YOU CAN'T USE THE OLD BFA WITH THE M240L'S NEW SHORT BARREL.

Short Barrel Needs **New** BFA

M26 BFA should be used with M240L short barrel

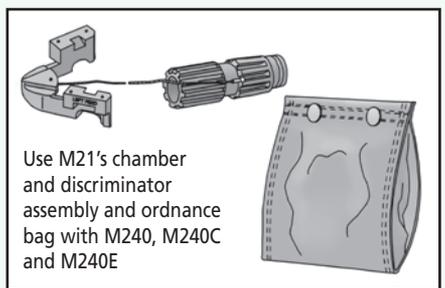
Dear Editor,
 MWO 9-1005-313-23-4 added a short barrel to the M240L. But the M24 blank firing attachment (BFA) can't be used with the short barrel.
 For the short barrel, you must use the M26 BFA, NSN 1005-01-565-6693. Until it arrives, continue to train with the standard barrel and the M24 BFA, NSN 1005-01-480-0289. Never use the M26 on the standard barrel or the M24 on the short barrel. You'll damage the barrels.
 I thought your readers would want to know.
